SUBJECT: Forwards clarifying info re postulated reactor coolant pump seized rotor & loss of all non-emergency AC events, per 840213 request.

Re: St. Lucie Unit 1  
Docket No. 50-335  
Reactor Coolant Pump Seized Rotor and  
Loss of all Non-Emergency AC Power

## ATTACHMENT

FIGURE A

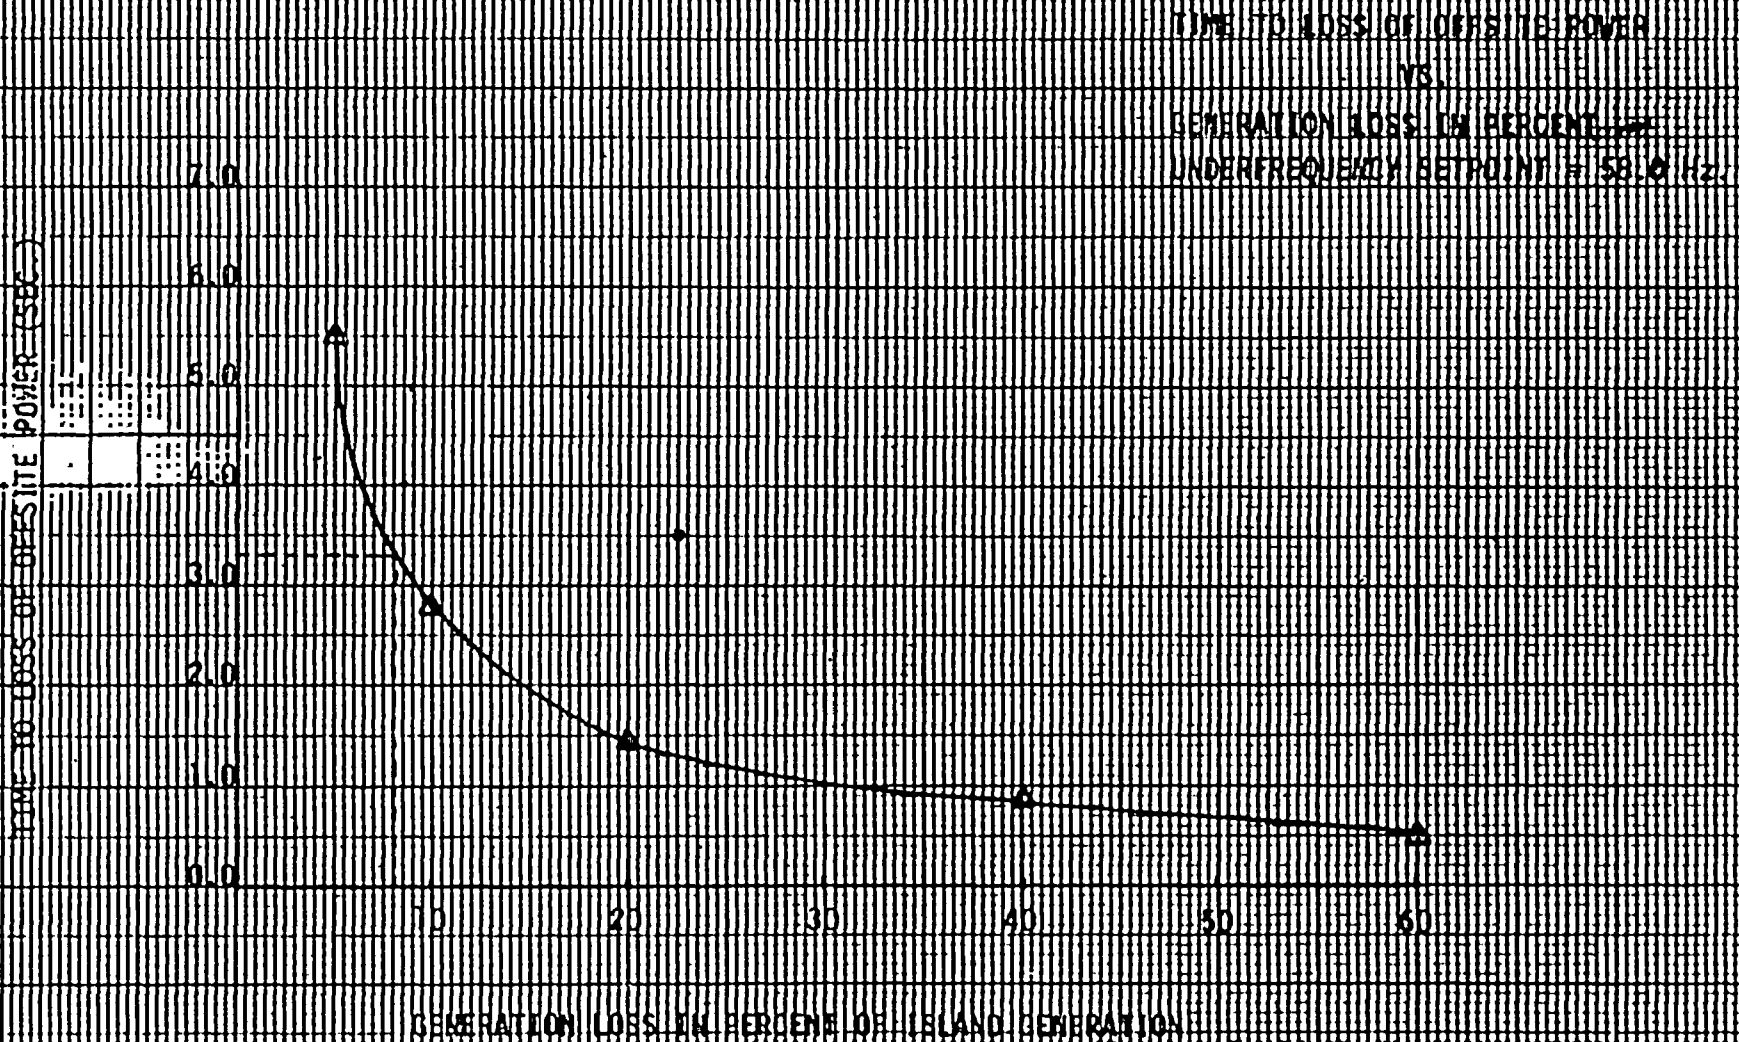
Question 1: Reference 1, Question 9 (two pages before graph): Claims 3-second time delay between turbine trip and LOOP is justified by C-E analysis. But this is justified only if St. Lucie output is less than 5% of subregional "grid power per your Ref. 14" p. 13, last two lines. Is this the case?

The above question indicates a misunderstanding that the power "output" provided by St. Lucie 1 comprises less than 5% of the "grid power." The document referred to as Reference 14 in the question specifies that the plant power generation is about 8% of subregional grid generation during minimum load conditions.

The 8% generation loss to the grid upon turbine trip was calculated by assuming that St. Lucie 1 was operating at 100% capacity at the time minimum load conditions exist on the grid. Therefore, the percent generation loss to the grid can be defined as the plant generating capacity (802 MWe) divided by the minimum yearly load. The minimum yearly load was estimated using typical daily, weekly and annual load patterns presented in Reference Q1-1. The minimum yearly load was determined to be approximately 50% of the summer peak load. The summer peak load for the Florida subregion in 1983 was estimated to be 20,046 MWe based on data presented in Reference Q1-2. These values lead to the estimated 8% subregional grid generation loss.

i.e.  $802 \text{ MWe (Unit Capacity)} \div 50\% \text{ of } 20,046 \text{ MWe (estimated minimum early load)} = 8\% \text{ generation.}$

If the generation loss to the grid were greater than 8%, the time to LOOP would decrease as shown in the attached figure. However, the loss of St. Lucie 1 is believed to be conservatively bounded by an 8% generation loss to the grid upon turbine trip. Even if the loss of St. Lucie 1 constituted a 9% generation loss to the grid, the time delay to LOOP would still be greater than three seconds. It should be noted that the methodology used to generate the attached figure incorporated several other conservatisms:

- No credit was taken for load shedding programs designed to arrest frequency decline. (i.e., initial rate of frequency decline is assumed.)
- No credit was taken for spinning reserve.
- The Florida model assumed "island" conditions (no support from neighboring grid systems, i.e., lower rotating inertia).
- Loss of offsite power occurs instantly at a grid frequency of 58.0 Hertz for SL1.
- All grid systems are standardly operated and specifically designed against unstable frequency oscillations resulting from loss of the largest generating unit on that grid.
